Proposed response to editors note page 158 line 6

Editors note page 158 line 6:

Figure 92-24—Style-1 example cable assembly

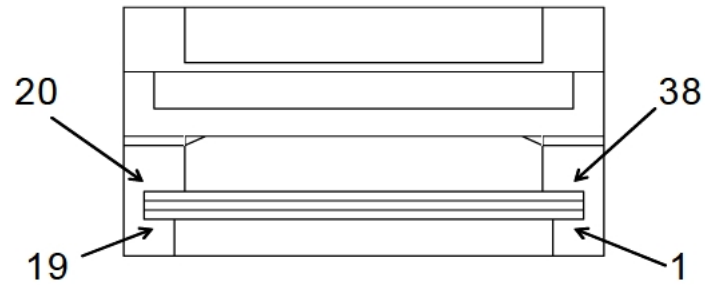
92.12.1.1 drawings for reference

Proposed Figure 110-6: SFP28 example MDI board receptacle

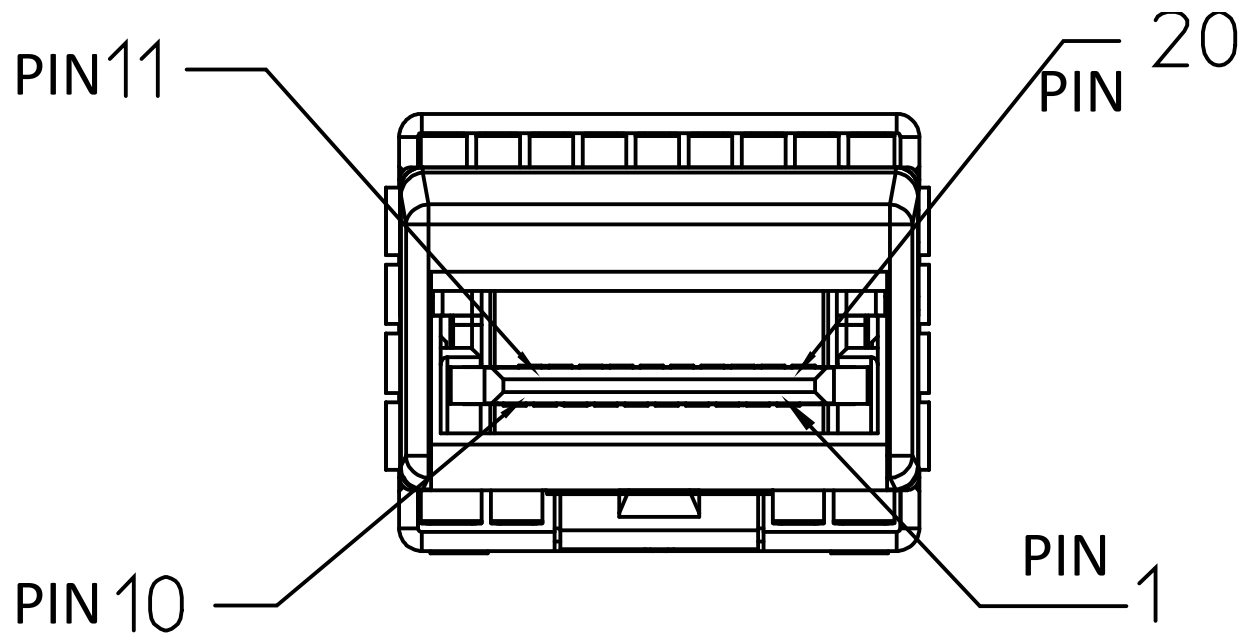
- Note: Need drawings of SFP28 plug and receptacle

- 1) Figure 110-5- SFP28 cable assembly plug
- 2) Figure 110-6- SFP28 receptacle

*Proposed change to text: 2nd reference to Figure 110-5
(line 2) should be 110-6.
